CITY OF TEMPE DEVELOPMENT REVIEW COMMISSION

<u>ACTION</u>: Request a Use Permit to allow two-story single-family residences in the R-4 Multi-Family District and a Development Plan Review for six (6) single-family residential units for HABITAT AT DON CARLOS located at 1969 East Don Carlos Avenue. The applicant is Habitat for Humanity.

DEVELOPMENT PROJECT FILE for DON CARLOS AT HABITAT (PL200109)

SHEET NO. L1.1

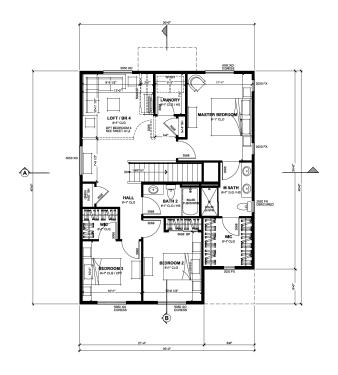
June 9, 2020 a formal submittal was made with all requisite materials. The recommendations from staff were made and no further issues identified. Staff suggested adding masonry wainscot to the base of the building and some minor modifications to the landscape plan. The street front landscape needed a 2nd street shade tree, and some ground cover adjacent to the sidewalk.

July 20,2020 a revised submittal was made. The recommendation for masonry base was not taken due to efforts to keep the homes affordable. The recommendations on landscape were not addressed. A condition regarding the street front landscape was added to enhance the public pedestrian streetscape.

- 14. Street trees shall be a minimum of 1 ½" caliper trunk.
- 15. Don Carlos shall have two required street trees of Ulmus parviflora by replacement of the northernmost Vitex with a shade tree located closer to the sidewalk.
- 16. The west side of the drive shall have additional ground cover north of the Cassia to provide more vegetation rather than gravel at the street front.
